03 CONSULTATION

REAR EXTENSIONS

PRE-APPLICATION RESPONSE

REFERENCE 2022/3645/PRE

[Above] Proposed Ground Floor Plan at Pre-Application

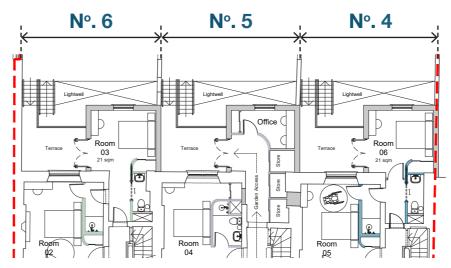
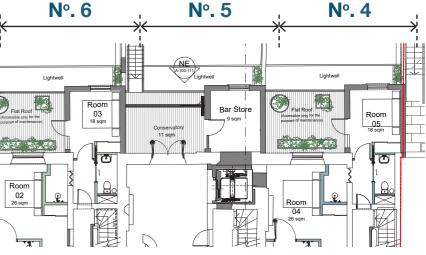
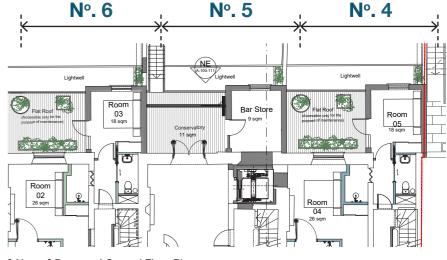
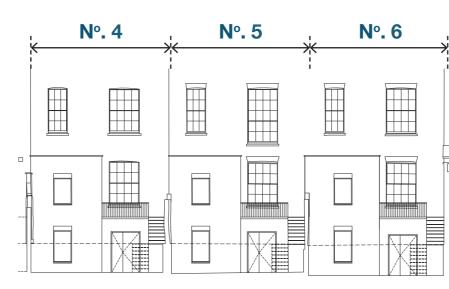
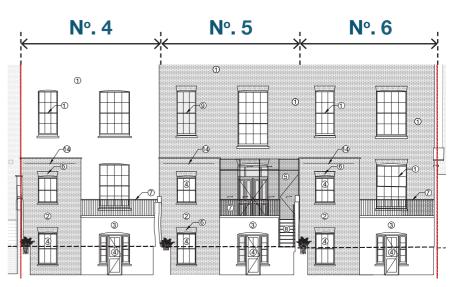
"It is proposed to create 3 new rear extensions at lower ground and ground floor levels. This is likely to be acceptable but the proposed wings currently show as coming very close to the rear window in the main rear room and they could be set further away from this window. The inclusion of an external stair and railed balcony/terrace also adds to the bulk of the proposed extensions and should be omitted from the scheme. It is noted that nos. 1-3 already have this similar arrangement. While nos. 1-3 have extensions which are similar to the proposed extensions, their detailing is guite poor and should not be replicated at nos. 4-6."

Please note that the proposal has now been revised to accommodate narrower 3 closet wings behind the three properties, set back from the rear windows and sized of a commensurate width to those constructed at No's 1 to 3 Bedford Place.

Please note that all external stairs have been removed and the light well and flat roof areas between the rear of the property and the garden are now all designated as inaccessible by guests and would only allow staff access for maintenance purposes. This is with one exception of a single stair flight, located centrally at the rear of No. 5 to allow access to the garden (the level of which is ½ a storey below the ground floor and ½ a storey above the lower ground floor.) Due to health and safety requirements whether flat roof areas or terraces, they all require some means fall restraint / arrest, hence the need for modest balustrades as proposed.

Please note, whilst there are proposed similarities and consistencies in the design of the massing of the closet wings to their neighbours at 1-3 Bedford Place, the proposed detailing is more sympathetic and coherent with the main building including brick arched sash window openings.

[Above] Proposed First Floor Plan at Pre-Application

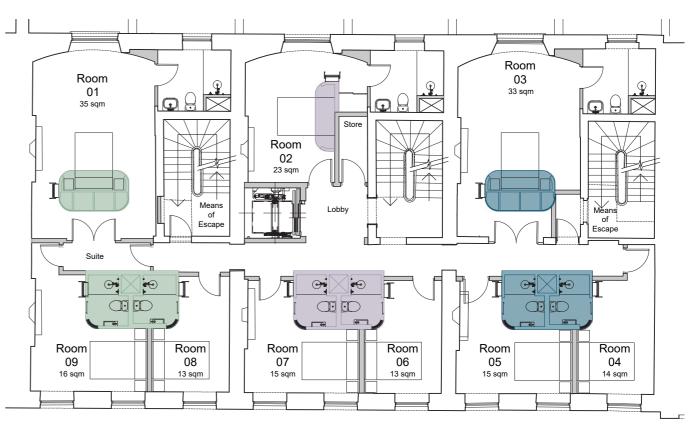
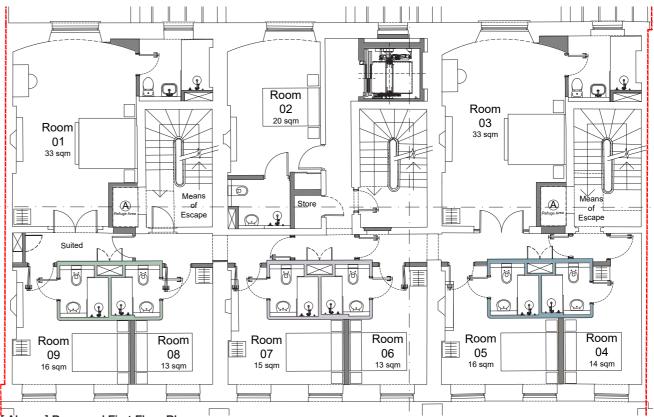
"The main intervention in terms of circulation is the creation of a lift. It is appreciated that options have been looked at as to how this can be accommodated while causing the least harm, but it unquestionably does cause harm to the significance of the middle building. It results in an uncharacteristic alteration to plan form, particularly at ground floor, and also involves the loss of the servants' staircase which, although late 19thC, is nonetheless of historic significance and in the original location of the servants' stair. These works would not be supported. None of the other listed buildings in Bedford Place appear to have been granted permission for a lift.

Provision of a lift is essential to the functioning of a modern and accessible hotel, benefiting a vast range of users. The proposed development presents an opportunity to improve access for all to the existing hotel.

The accommodation of a lift to serve 5 storeys of this building is an essential ingredient of 4* boutique, town house style of hotel of this nature.

In order to accommodate the lift, the client and design team have taken a heritage led approach to this building whereby perceived harm has been counterbalanced by considerable benefits such as the re-establishment of traditional details and have been guided by Historic England's guidance Easy Access to Historic Buildings (June 2015). Further to preapplication advice and review, the proposal has been revised to relocate the lift at the rear of the main staircase in No.5. Similar approach has been taken elsewhere in the terraces on Bedford Place.

[Above] Proposed First Floor Plan at Pre-Application

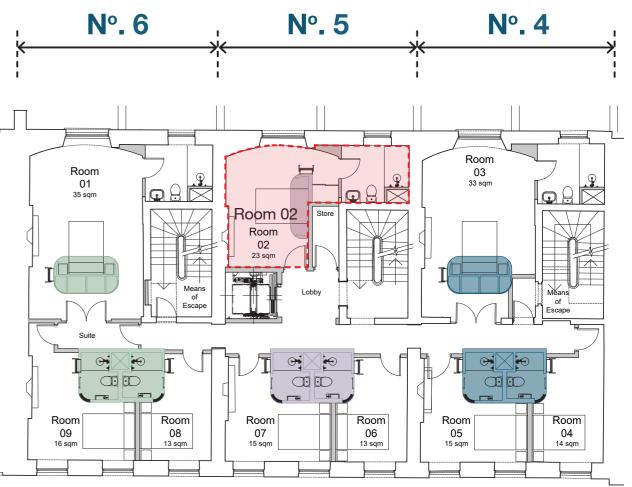
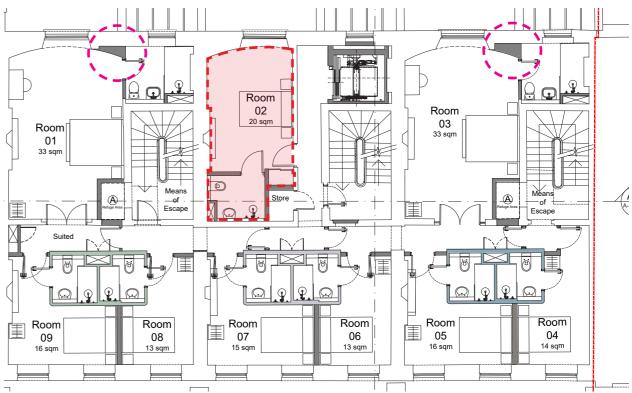
"At first floor level the creation of apsidal walls to the rear rooms could be a benefit if it can be established that these spaces were originally apsidal and that the corridor is not original to the building. The corridor appears (in some areas) to be constructed of lath and plaster, and is very similar to 1-3 Bedford Place which had the same arrangement in 1907 to which some kind of partial apsidal was added in 1907."

Due to the proposed lift location in No. 5 Bedford Place, the corridor is proposed now to remain to separate communal circulation from bedroom accommodation. The proposal to open up the 2 rear rooms in both No's 4 and 6, remains however based on both the evidenced implementation of this proposal at No's 1-3 Bedford Place and also due to the evidence discovered (see picture) of the existing curved cornice in No. 4 above the opened up modern ceiling below. Although it may appear that some of the corridor walls have been constructed in a traditional manner it seems that they may not be original and that by opening up these areas, the historic significance would be retained and enhanced.

[Above] Proposed Pre-application First Floor Plan

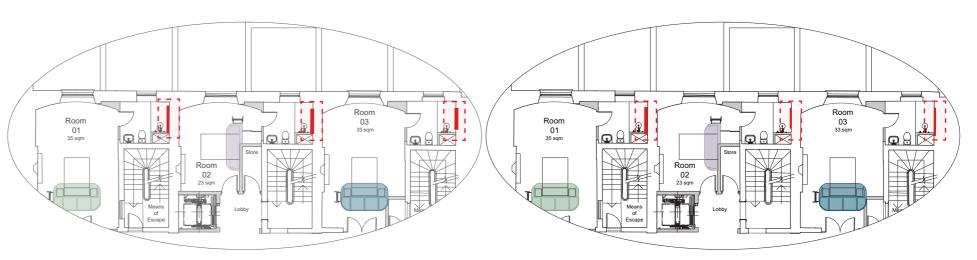
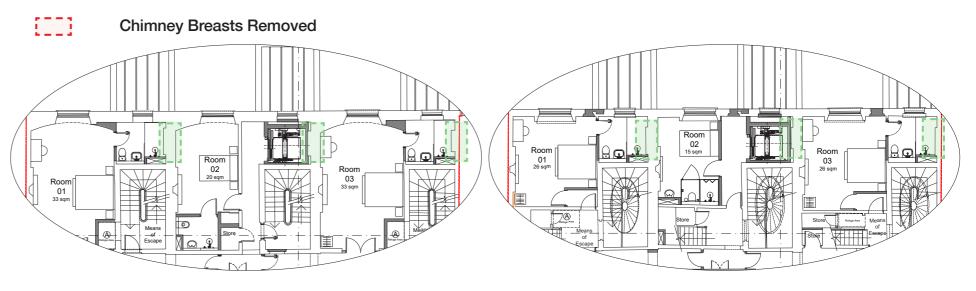
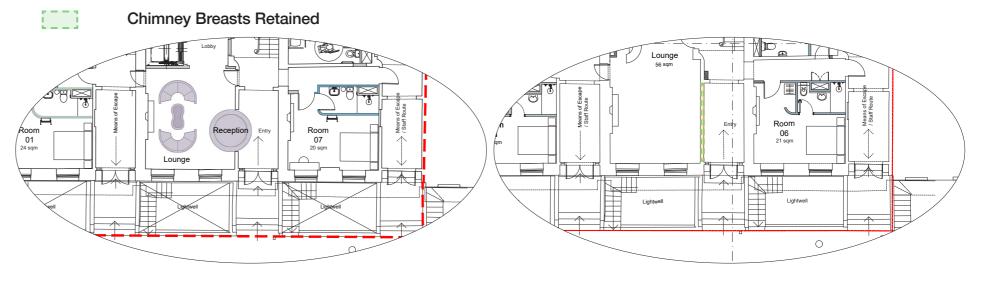
"It is also noted that the current proposal appears to propose removal of the chimney breasts to the smaller rear rooms which requires clarification as this is very unlikely to be acceptable (see extract plans below).

An opening in the spine wall between the entrance hall and the front room of the middle building, to create a reception area, would not be supported as it alters the cellular plan form of the building which is part of its historic character."

Please note that the revised scheme retains all of the chimney breasts within the smaller rear rooms.

Please also note that the revised scheme does not include any openings in this spine wall any more.

[Above] Proposed First Floor Plan at Pre-Application

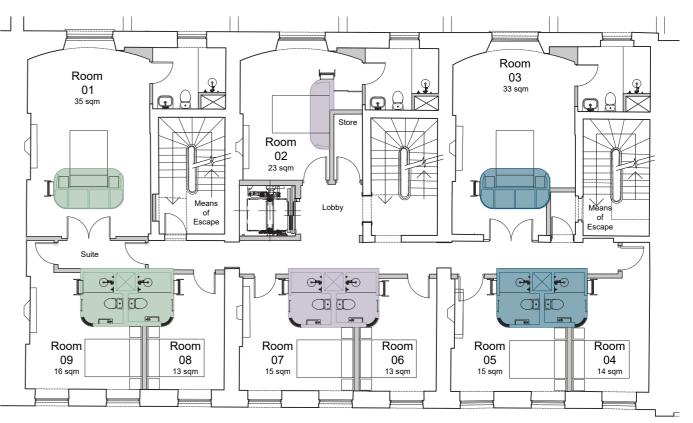
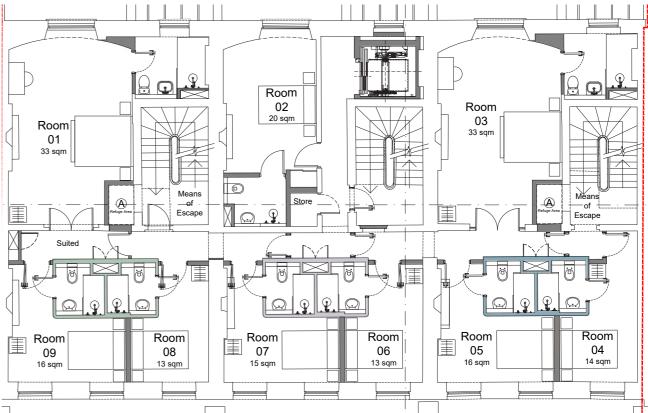
"Some form of pod structure is likely to be acceptable in the positions indicated on the basis that they are largely re-providing wet services in locations which already have plumbing and in locations without plumbing they act as a piece of furniture (although the bed/wardrobe structures appear to require wiring in for lights etc and so would not be exempt from LBC). The inclusion of an upper-level seating area results in excessive height and bulk and the historic proportions of the room would be more legible were the upper enclosures not included. The pods at ground floor are harmful to the plan form when compared to the existing plan form, but it is accepted that en-suite provision is a reasonable provision for a hotel and the pods would not be full-height at ground floor".

The support for these features is understood and appreciated and largely remains throughout the proposed, revised scheme. Please note that upper-level seating areas above pods have now been removed. Pods remain at less than full height at both the ground and first (taller and most significant) floor levels.

[Above] Proposed Ground Floor Plan

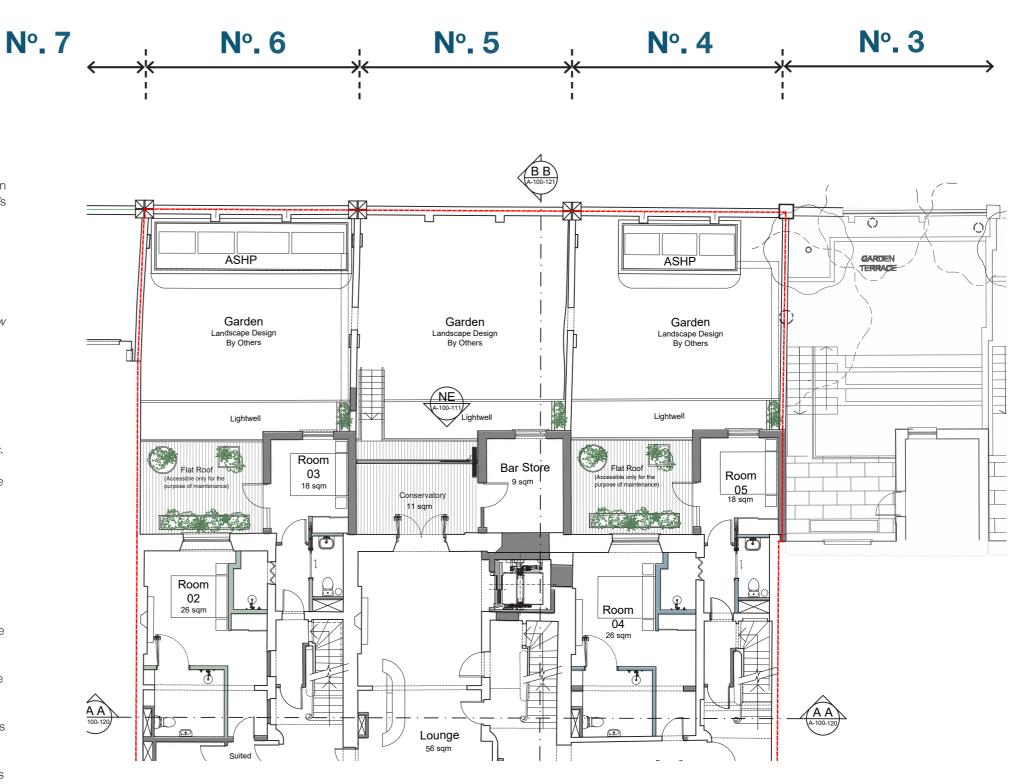
"The neighbouring property at no. 7 is occupied by a hostel / hotel (Pickwick Hall Hostel). A new terrace area would be created at upper ground floor level on the rear of no 6 on the boundary with no. 7. Given the use of the building and the transient nature of the occupiers the proposal would not have an adverse impact on the amenity of the occupiers of the hostel in terms of overlooking.

The nearest residential properties lie directly to the southeast of the site at nos. 1-3 Bedford Place. These buildings have been separated into 6 self-contained flats. The proposal would include the extension of the existing closet wings at lower ground and ground floor level on nos. 5 and 6 Bedford Place and erection of a new two storey rear extension at no. 4. The extension would be approximately 4m wide by 3.7m deep by 6.4m in height and would be located on the boundary with no. 3. No windows would be installed in the side elevations of the extensions so there would be no direct overlooking into neighbouring windows or gardens.

As previously mentioned, all external stairs have been removed and the light well and flat roof areas between the rear of the property and the garden are now all designated as not accessible by guests and would only allow staff access for maintenance purposes. (This is with the exception of a single stair flight, located centrally at the rear of No. 5 to allow access to the garden which is adequately set back from both numbers 3 and 7 Bedford Place by virtue of the property numbers 4 and 6 in between.

The accompanying sunlight and daylight assessment confirms that there will be no material loss of either daylight or sunlight to the occupants of No 3 Bedford Place. In respect of outlook, we note that the proposed relationship between No 4 and No 3 will be identical to the consented relationship between No's 1 and 2, and between No's 2 and 3. In granting that consent, officers took the view that the quality of accommodation, including the outlook, was "excellent". In full officers stated:

The depth of the rear extension in No.4 has therefore not been amended. In design and heritage terms, we consider that the uniformity in form, depth and massing from the consistent closet wing extensions will significantly benefit the rear elevation of the group."
